Camden Local Planning Panel

CLPP01	DA/2020/232 - Alterations and Additions to an Existing Heritage Building (Gledswood Homestead) and Use as a Centre-Based Child Care Centre - 900A Camden Valley Way, Gledswood Hills	6
	Attachment 1: Recommended Conditions:	11
	Attachment 2: Remediation Action Plan:	30
	Attachment 3: Hazmat Report:	100
	Attachment 4: Architectural Plans:	127

SUBJECT: DA/2020/232 - ALTERATIONS AND ADDITIONS TO AN EXISTING HERITAGE BUILDING (GLEDWOOD HOMESTEAD) AND USE AS A CENTRE BASED CHILD CARE CENTRE - 900A CAMDEN VALLEY WAY, GLEDWOOD HILLS

DA Number:	2020/232/1
Development:	Alterations and additions to an existing heritage building (Gledswood Homestead) and a change of use to a centre-based child care facility for 80 children and associated site works
Estimated Cost of Development:	\$603,860
Site Address(es):	900A Camden Valley Way, Gledswood Hills
Applicant:	Mr Rocco Nasso
Owner(s):	Caldla Pty Ltd
Number of Submissions:	25 submission (24 objections and one letter of support)
Development Standard Contravention(s):	None
Classification:	Nominated Integrated development
Recommendation:	Approve with conditions
Panel Referral Criteria:	Partial demolition of a herit

Project Development Application Proposed Child Care Centre		
Project address 900 Camden Valley Way, Gledswood Hills.		
Client Roy Nasso		
Title Proposed Ground Level		
Drawn L.D.P.	Scale 1:200 @ A1	Checked
Job No. 2434	Drawing No. 06	Issue B

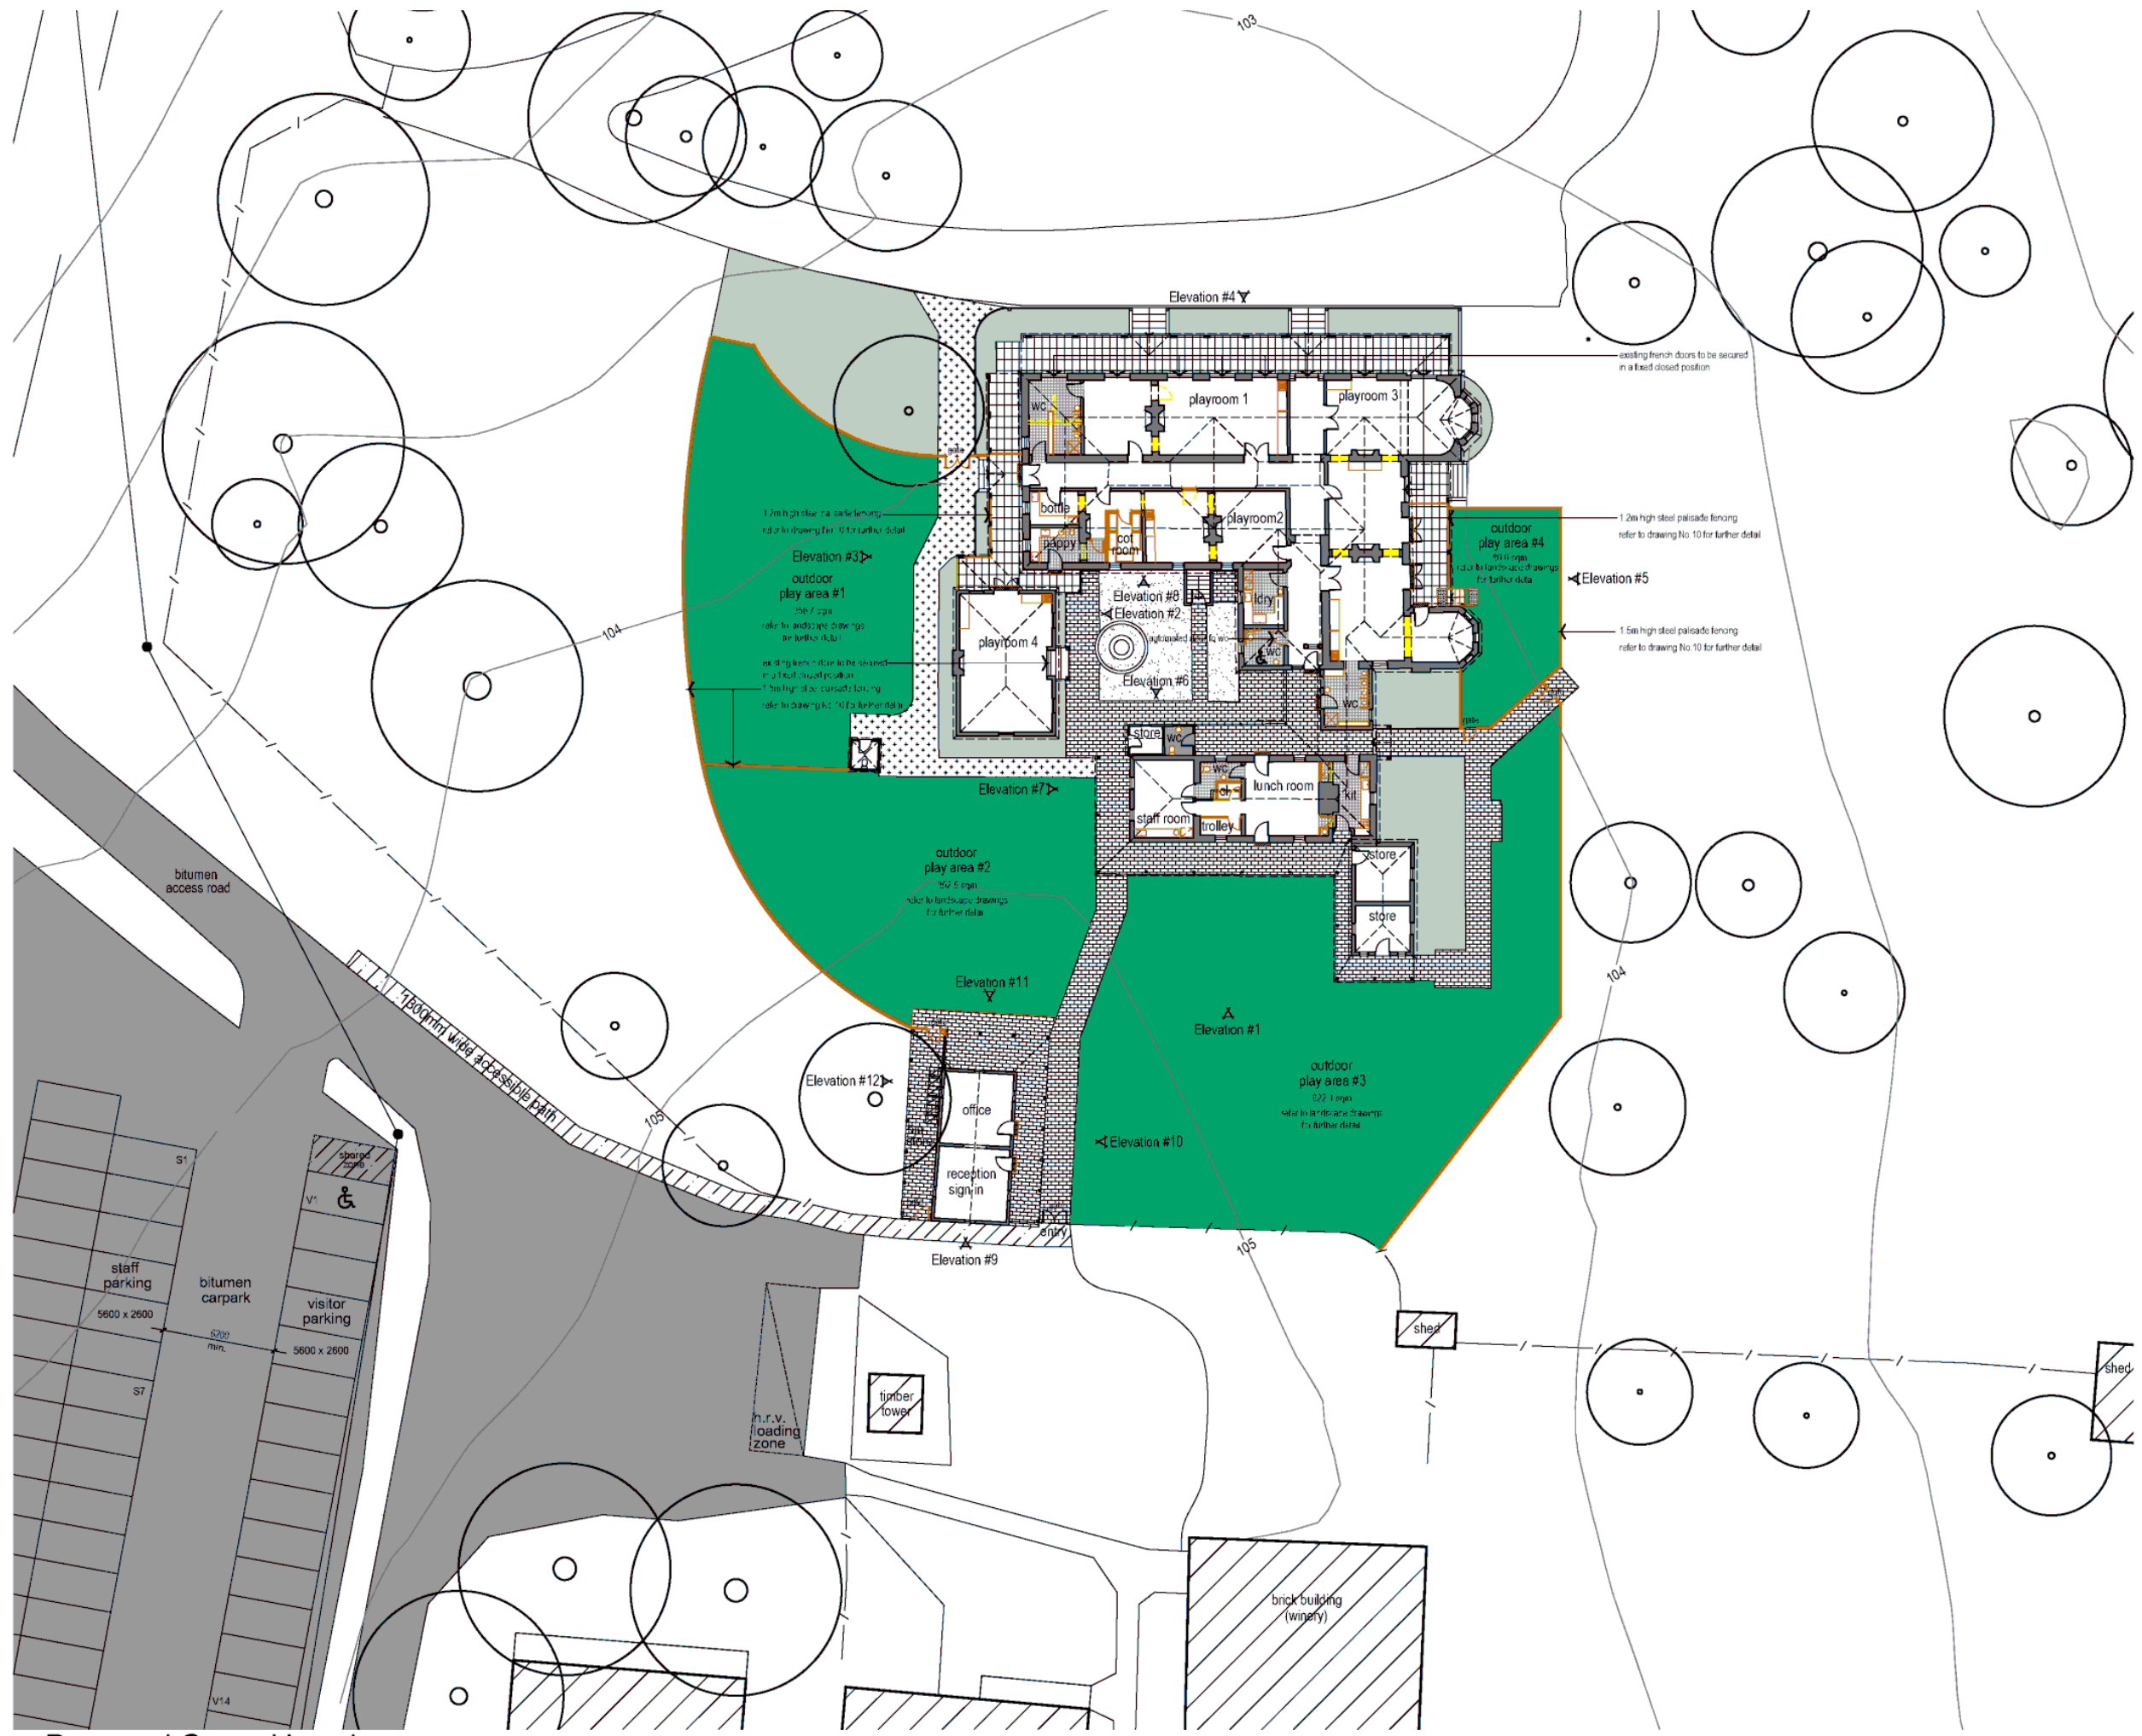
- (5) **Modified Documents and Plans** - The development shall be modified as follows:
- a) Amend Drawing 6 Issue B, Proposed Ground Level, prepared by Architex, dated 3 August 2021 to match Drawing 4 Issue B, Proposed Ground Level, prepared by Architex, dated 3 August 2021 to ensure the amended door openings are amended in Drawing 6.
